RE: Preliminary Plan # 1-97044B
New Covenant Fellowship Church

SUBJECT: Preliminary Plan 11997044B
New Covenant Fellowship Church

Subject: Preliminary Plan Amendment – Plan Number 11997044B
New Covenant Fellowship Church

NEW COVENANT FELLOWSHIP CHURCH
 APPROXIMATE CORRIDOR CITIES TRANSITWAY IMPACTS
 (PRELIMINARY)

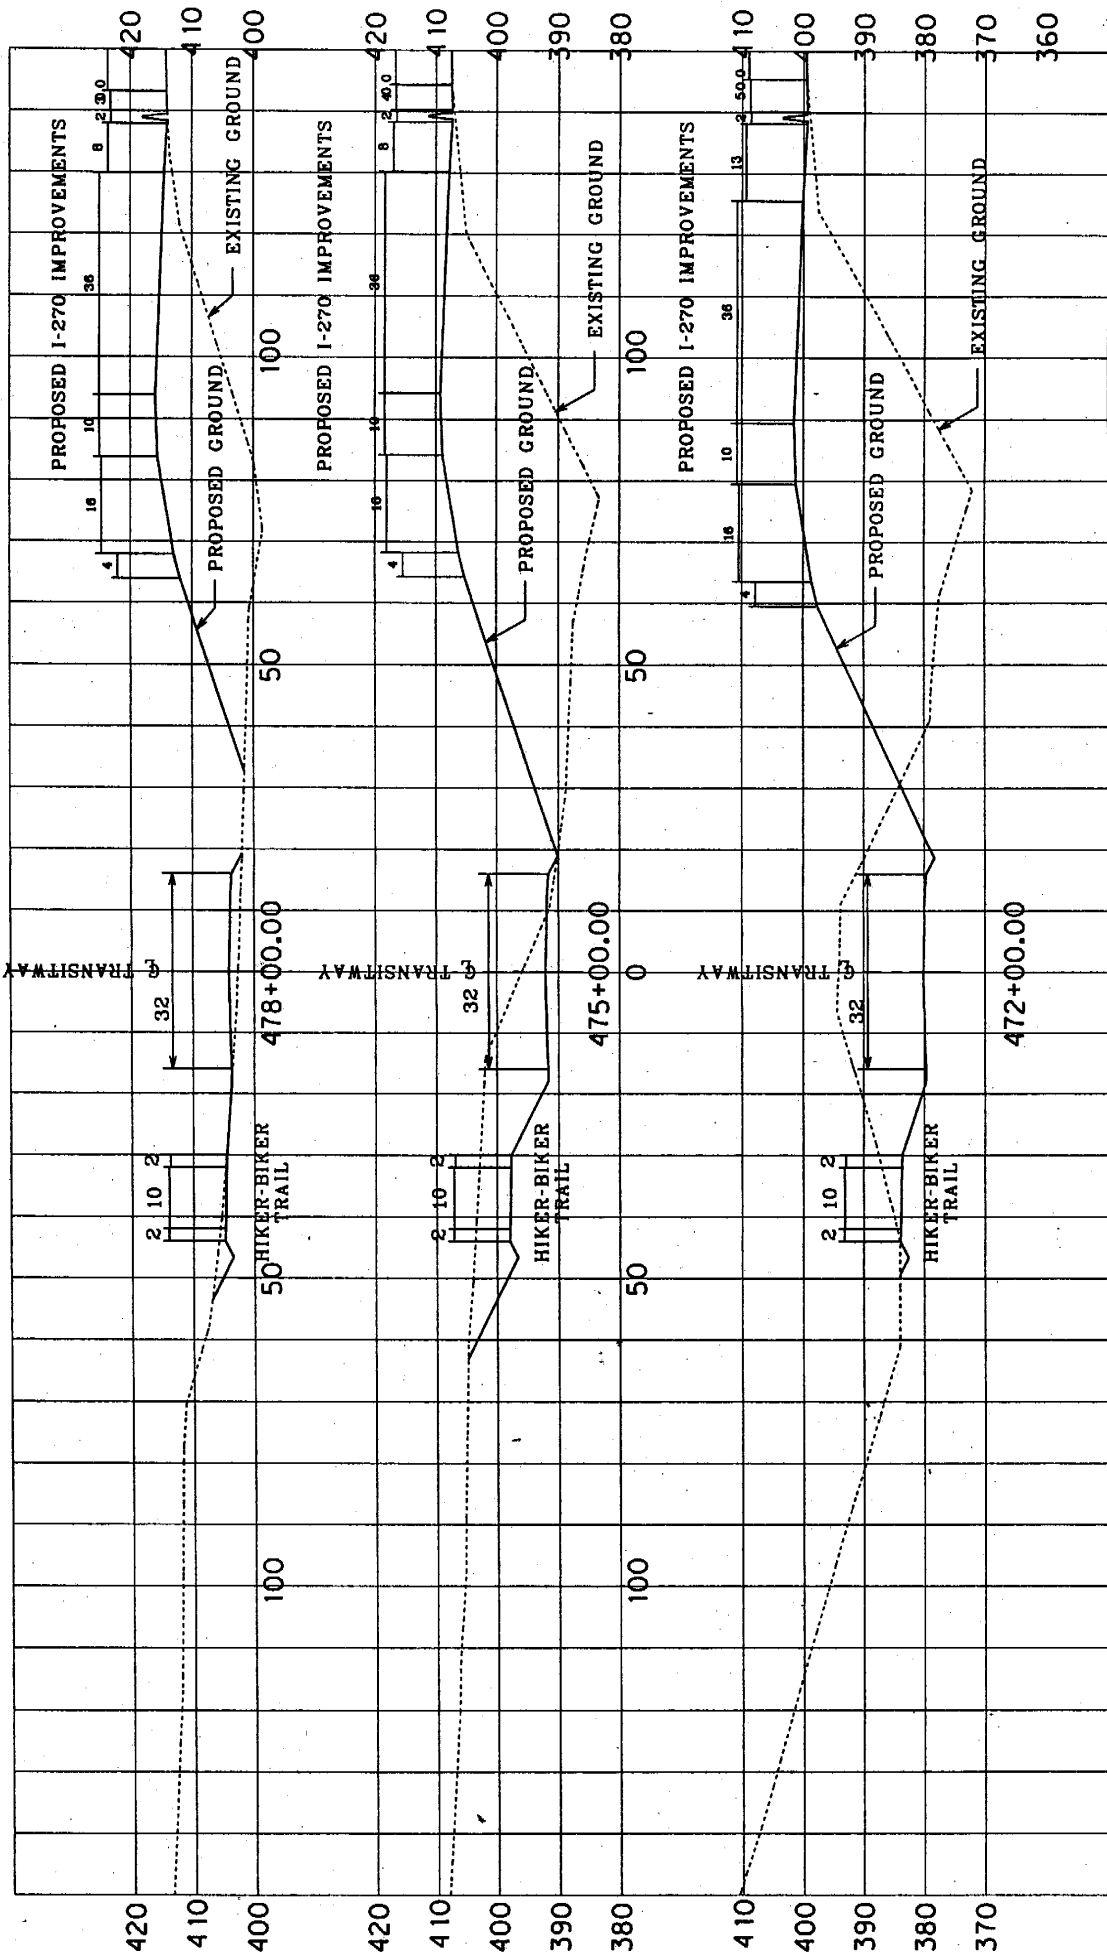
The area dedicated for public use on the record plat is shown to be 182 feet from the I-270 centerline. The MDOT current project planning effort at this time indicates there is a need for an estimated 260 feet from the I-270 centerline to accommodate the planned improvements (additional roadway lanes, CCT alignment, hiker/biker trail alignment, and related grading slopes). The estimate of 260 feet can vary slightly along the parcel's eastern perimeter and is subject to further analysis and documentation by MDOT.

Staff has met with applicant regarding this issue and the applicant has agreed to grant MDOT an easement in perpetuity for the area delineated in the MDOT memo dated October 27, 2005. The area in the memo is essentially the area identified in the current DEIS as being required for the planned I-270 improvements, including the highway improvements, transitway corridor, hiker/biker trail, and associated transitional slope area. The easement would be in exchange for MDOT holding the applicant harmless from any costs and claims arising from the operation and construction of the highway, transitway, and hiker/biker trail. In addition, the applicant would grant MDOT a construction easement to be used for access, staging, equipment/material storage and other related construction activity during the construction phase of the project.

Staff estimates from the applicant's submitted plan that approximately 69 spaces located in the (east) perimeter row of the main church parking lot may be affected by the additional right-of-way requirement. The actual number could be more or less, depending upon more detailed site engineering measurements. The one single row and two double rows of parking designated for use by residents and visitors to the senior housing do not appear to be within the I-270 right-of-way requirement. As noted in the staff memorandum of April 6, 2005, related to the Special Exception, the existing parking capacity exceeds the amount required by ordinance (by 175 spaces) but is fully used on weekends during church services.⁵

2. Prior to issuance of a building permit, the applicant shall provide documentation that it has reached an agreement with the Maryland Department of Transportation (MDOT) to grant an easement in perpetuity to MDOT as generally described in the attached letter of October 27, 2005 (and related attachments) for the planned I-270 improvements, including the highway improvements, Corridor Cities Transitway (CCT) corridor, hiker/biker trail, and associated transitional slope area. In addition, and also prior to the issuance of a building permit, the applicant shall provide documentation that it has reached an agreement with MDOT that, upon the request of MDOT, the applicant shall grant MDOT a construction easement as described in the MDOT memo of October 27, 2005 to be used for access, staging, equipment/material storage and other related construction activity during the construction phase of the project.
